Re: Planning Application Ref. 2560019 – Proposed Biogas / Anaerobic Digestion Facility

Re: Formal Objection to Planning Application 2560019 by Roadstone Ltd – Killough Renewable Energy Development (Anaerobic Digestion, Biomethane, Gas Upgrading, & LBG Facility)

Environmental Report on: Proposed Biogas & LNG Facility by Roadstone at Killough Quarry,
Gaile Townland, Holy Cross, Co. Tipperary. Planning Application No:2560019

Figure 4.2

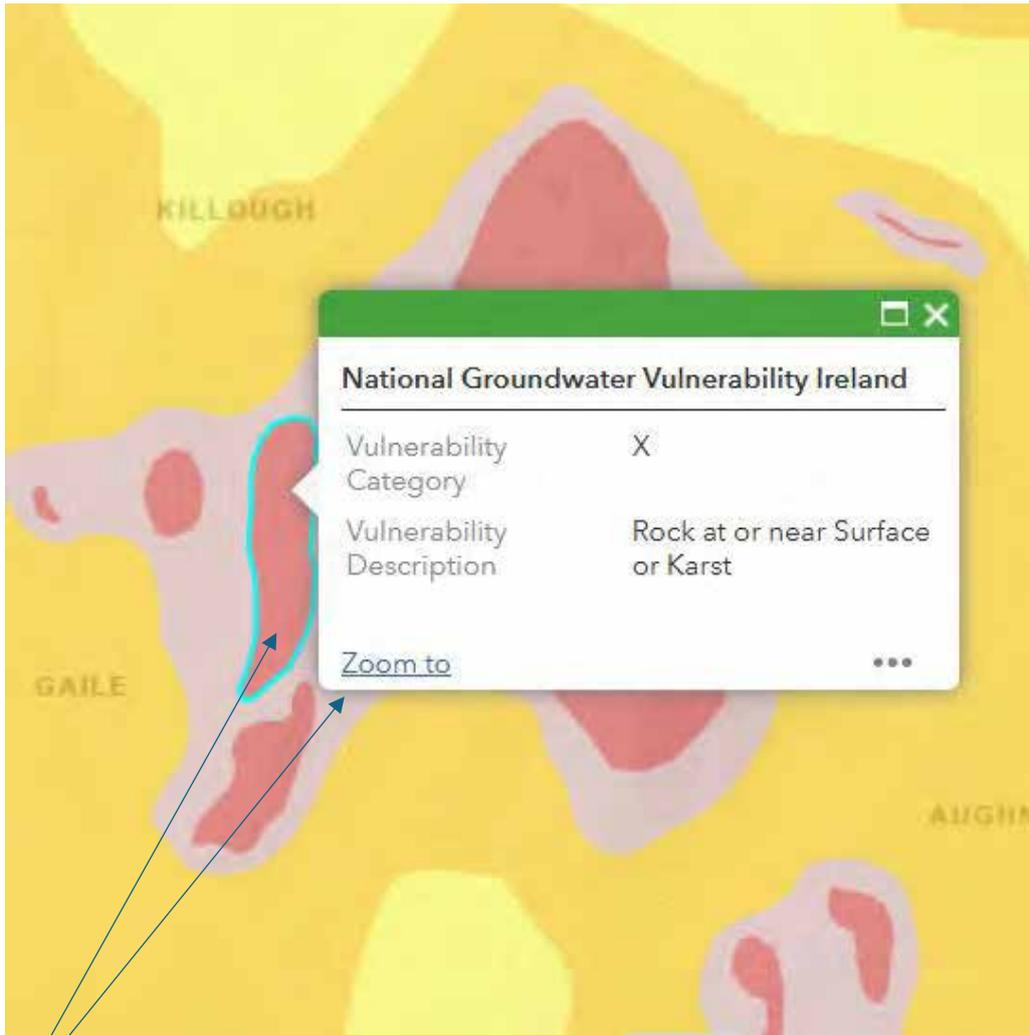
The groundwater vulnerability index for the proposed site is ‘X’ karst rock. GSI’s definition of Extreme “X” vulnerability is bedrock at or within ~1 m of the surface, which inherently poses a high risk of rapid contaminant entry when containment fails. And ‘E’ extreme vulnerability rating. (Figure 4.2 & 4.3)

There is no soil at this site to offer any attenuation if leakage, spillage, or accident were to occur.

Figure 4.4

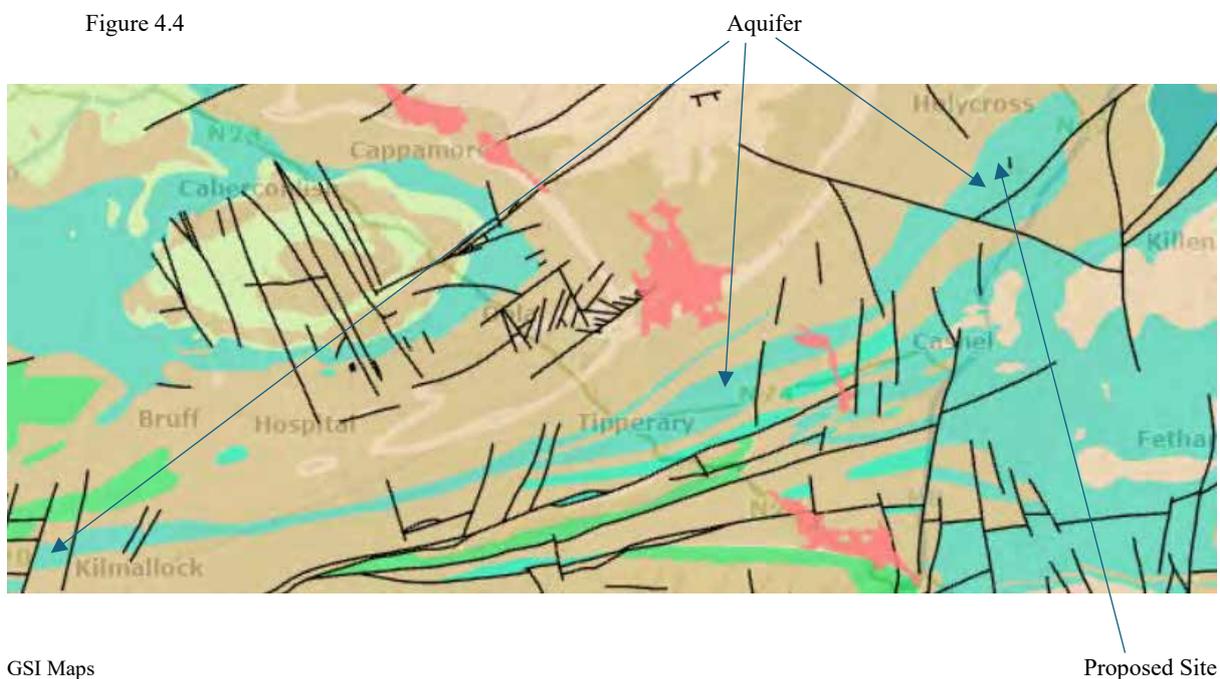
Rkd aquifers can provide significant yields to wells and groundwater supplies. However, the same karst characteristics can also permit rapid and unpredictable contaminant transport over long distances (Figure 4.4), as demonstrated by Irish tracer studies in comparable limestone settings (e.g., Drew, 2008; Drew, 2018; Naughton et al., 2018). (Figure 4.4)

Figure 4.7

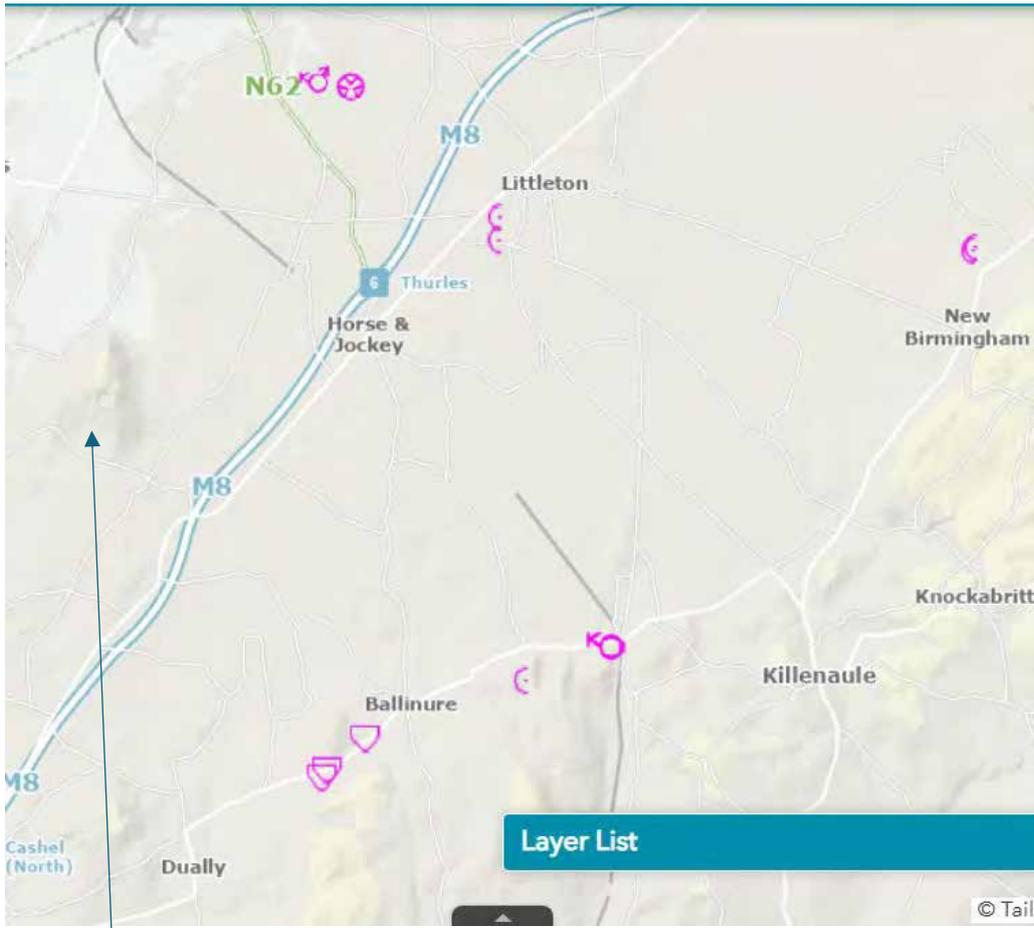
Killough Hill acts as a recharge area for the underlying aquifer and the tributaries, which then feed into the River Suir. There are numerous karst features in the immediate vicinity of the proposed development that clearly demonstrate the extent of fluvial karst development, the

proximity of the water table to the surface, and the importance of proper testing and tracing to understand flow patterns and protect human health. (Figures 4.7 & 4.8)

Figure 4.9 River Suir_080 under pressure from farming activities

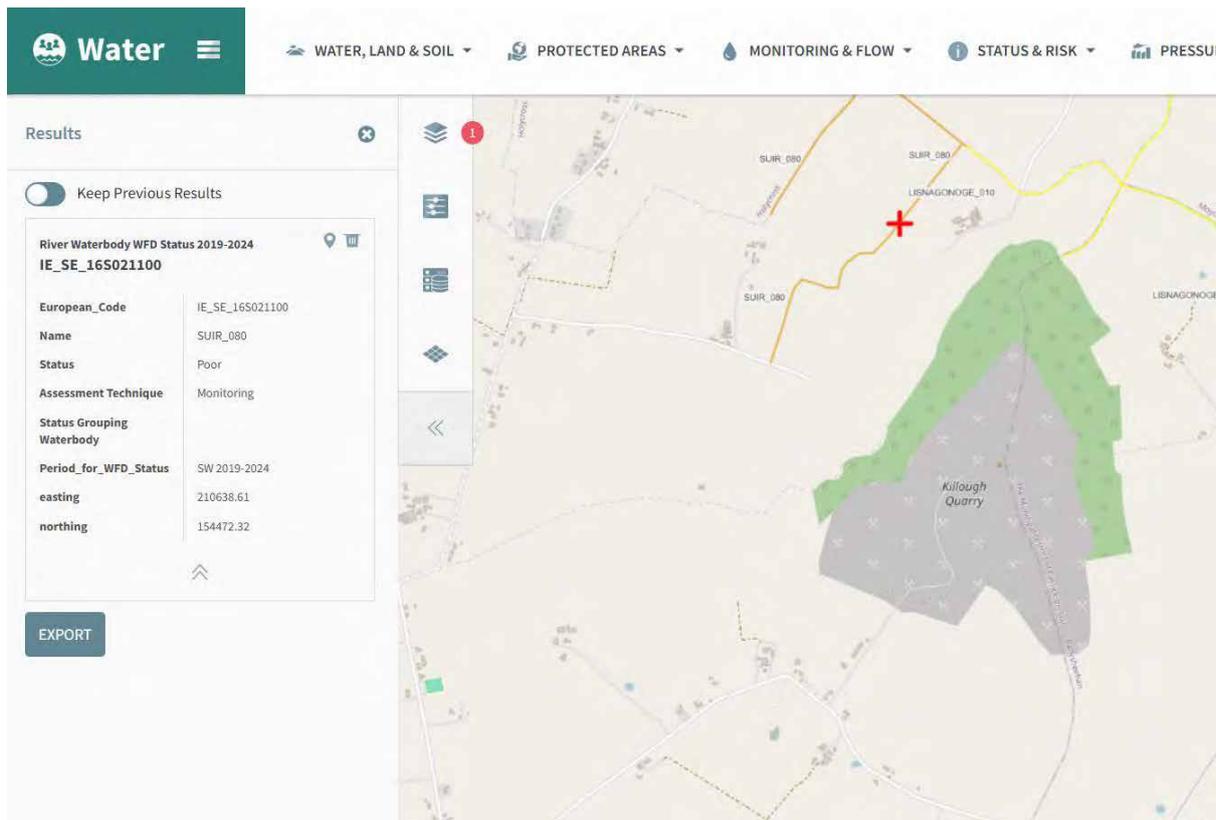
The EIAR notes that the proposed development site is split between the SUIR_080 and SUIR_090 River Suir sub-basin catchments. Downstream receptors include local rivers and streams (including a local stream (Lisnagonoge) with eventual confluence to the Lower River Suir SAC). The EIAR also reports that the closest EPA biological monitoring station is Holycross Bridge (c. 3.8 km northwest of the site), where the most recent reported Q value is 3 (poor/unsatisfactory), representing a decline since 2020 (Q 3-4). This baseline condition reduces the margin for error and strengthens the Water Framework Directive no-deterioration obligation for any new high-risk activity in the catchment (EIAR Chapter 7, paras. 7.125-7.135 and 7.127-7.129; Table 7-12).

Figure 8. Current planning permission for all extraction and associated works at Killough Hill.
Proposed Planning Area in Blue. Tipperary CoCo,
Permitted planning areas at Killough Hill, pNHA by Tipperary CoCo

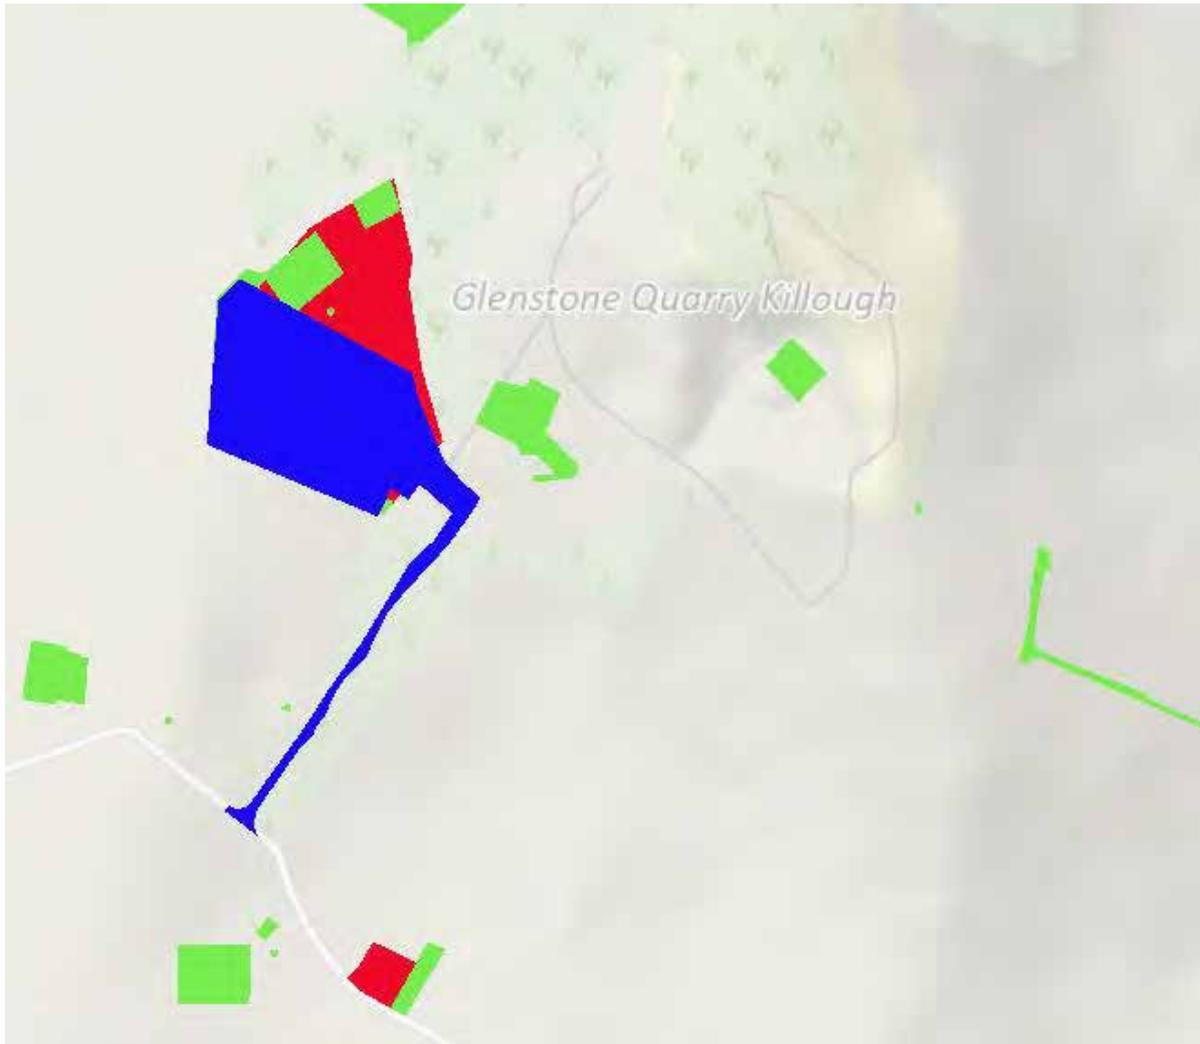
Figure 9. The extraction area does not match the area granted in the planning. See figure 8.

Figure 1: Sight Distance Triangle X-distance of 4.5m not shown. Sight Distance Triangle to North traverses the from garden of house. Consent to this has not been provided.

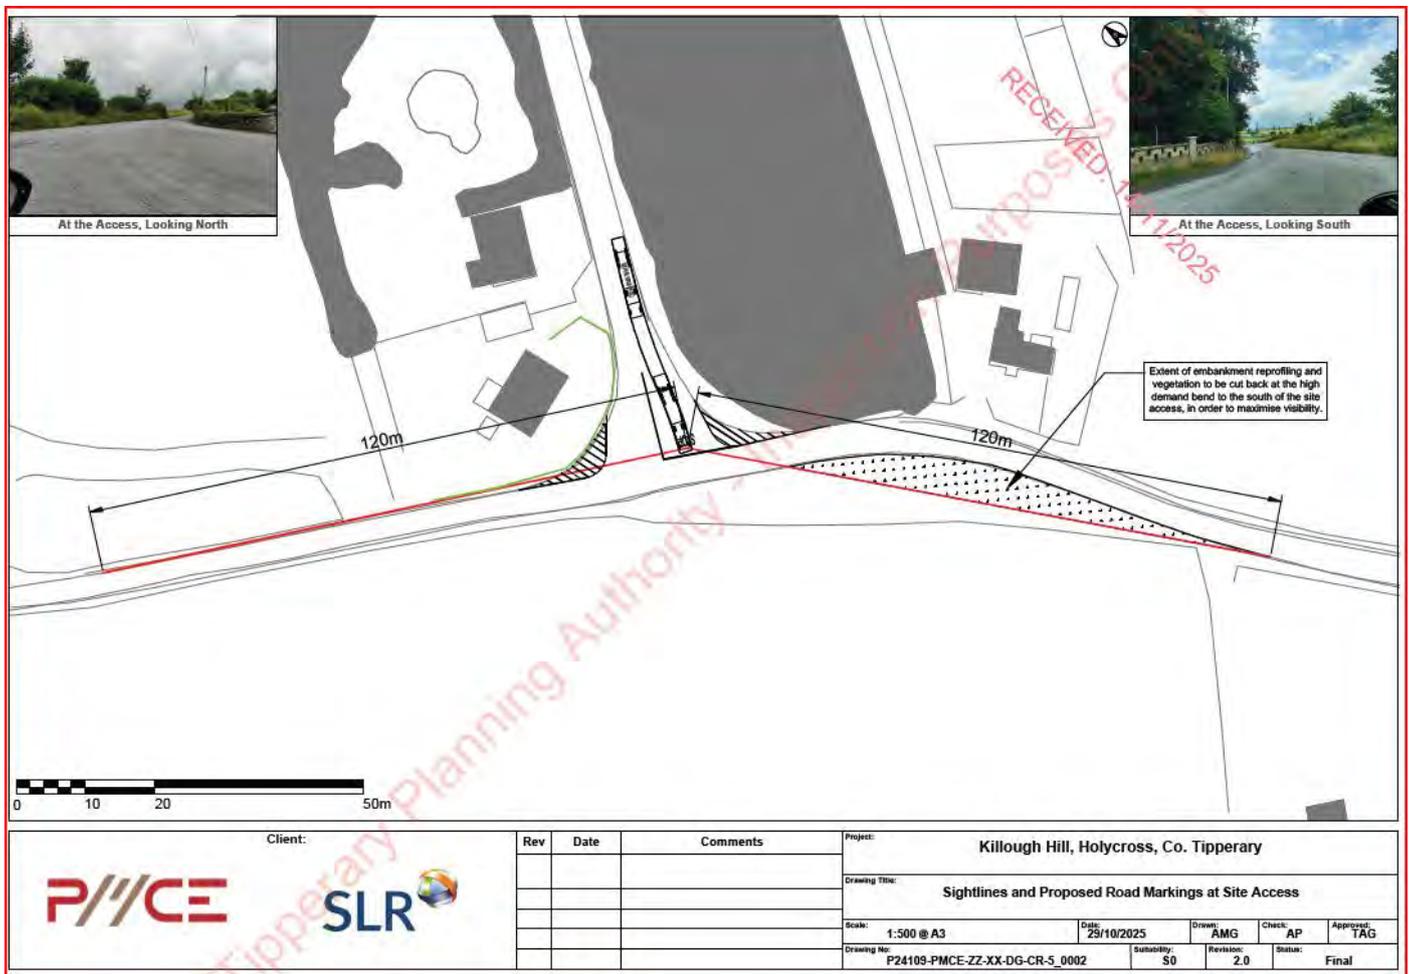
Response MLavelle: Current traffic count over a one-day period is totally inadequate for an industrial development of this size. There is a suggestion locally that the quarry traffic was switched to alternative quarries for the day of the traffic count.
